**ADDENDUM 3****Addendum #** 3**Date Issued** January 28, 2026**Project Name | Job #** White Earth Withdrawal Management Facility | 20237410**Bid Date | Time** *Thursday, February 5, 2026* | 3:00 pm

THIS ADDENDUM AMENDS AND BECOMES PART OF THE CONTRACT DOCUMENTS FOR EAPC PROJECT 20245580 DATED 12/5/2025, RESPECTIVELY. EACH BIDDER SHALL ACKNOWLEDGE RECEIPT OF THIS ADDENDUM BY MARKING THE ADDENDUM NUMBER AND DATE ON THE BID FORM.

DRAWING TITLE
 ARCHITECTURAL SITE
 PLAN, DETAILS

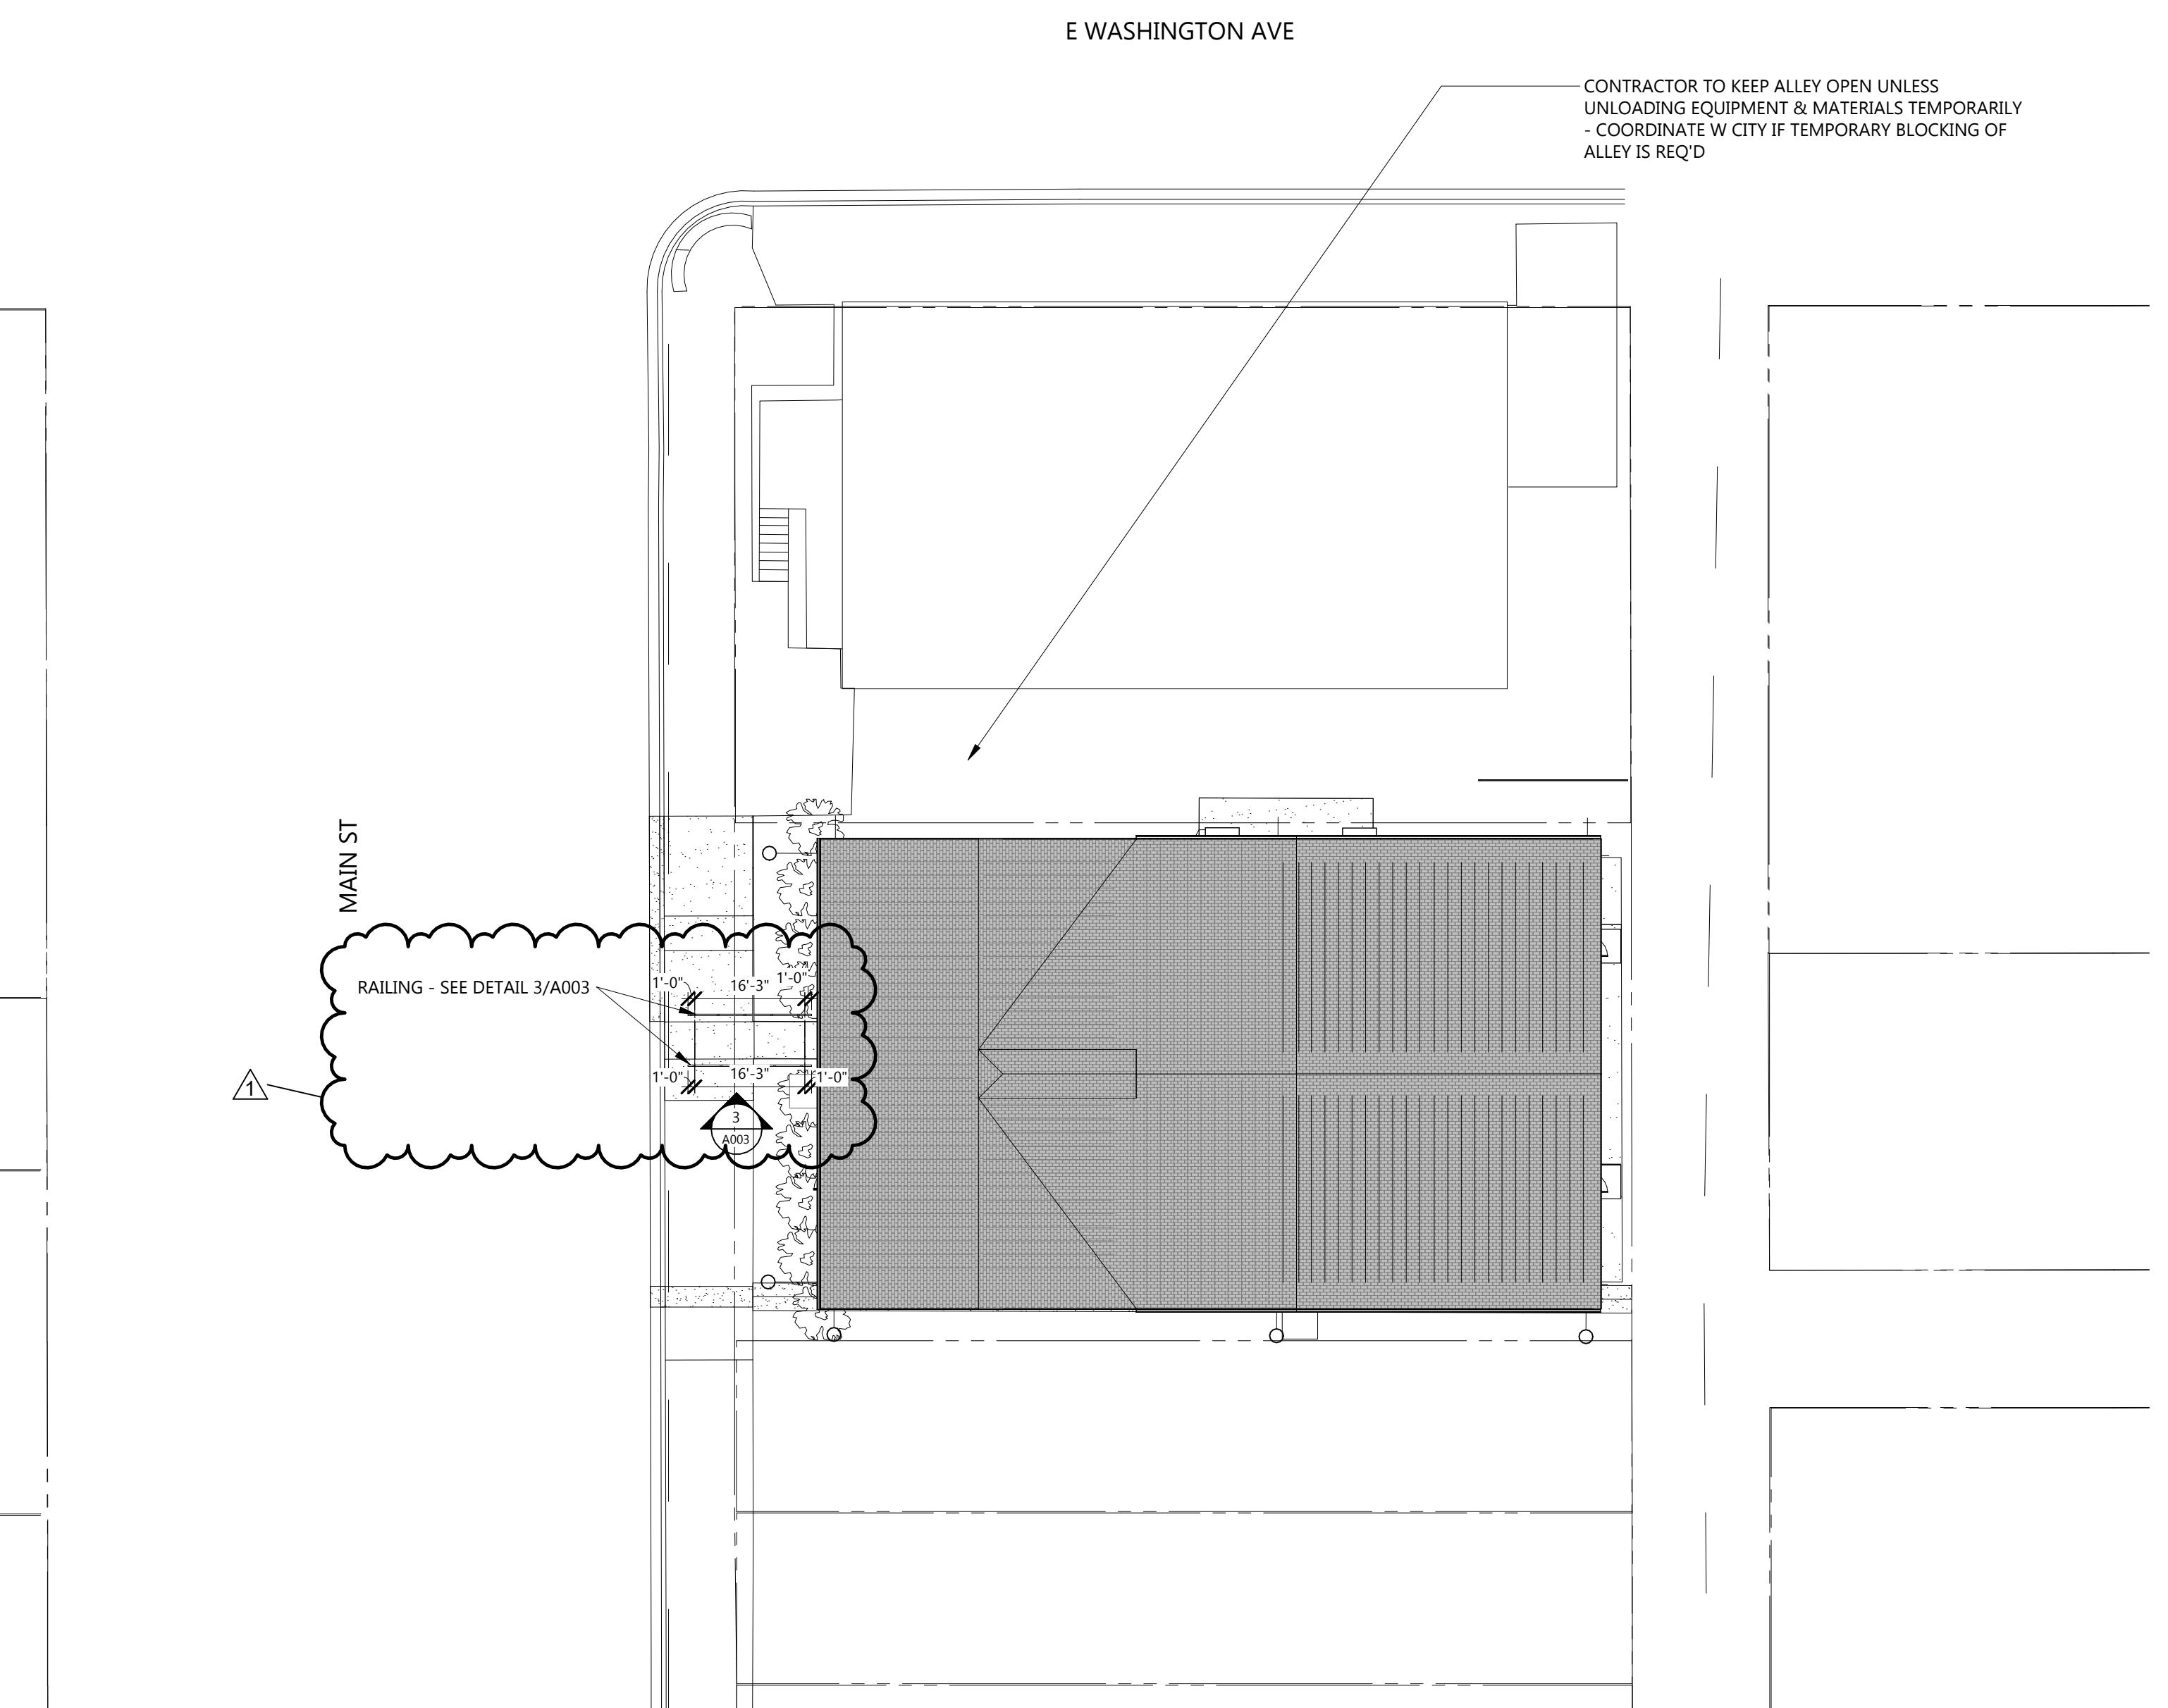
Clarification to Civil: Sloped sidewalk area is 7' long with 4' landings at top and adjacent to building. Provide rail to cover 11' of length.
